RECALL: NHTSA 21V928

SUBJECT: Incorrect Tire Size on Placard Label and Tire Pressure Label

APPLIES TO: Roadtrek: 2021 Zion Slumber and Play models

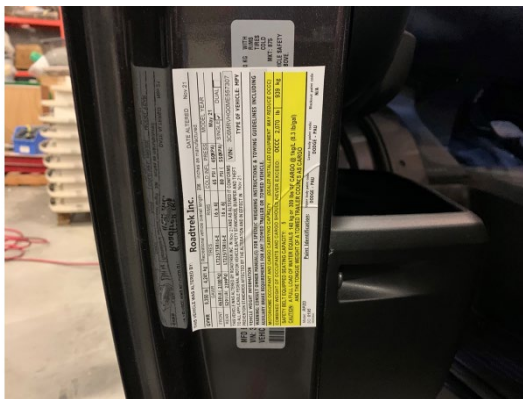
CONDITION: Placard and Tire Pressure labels incorrectly state the tire size as **LT245/75R16E**

STEP 1: Find location of the Placard label on the driver's door and wipe the surface clean with a damp cloth and allow to dry.

STEP 2: Peel off the backing of the new placard label and apply it over top of the original label with the same orientation

CORRECTION: Placard label and Tire Pressure label need to be replaced with new labels that state the tire size as **LT 225/75R16 E**
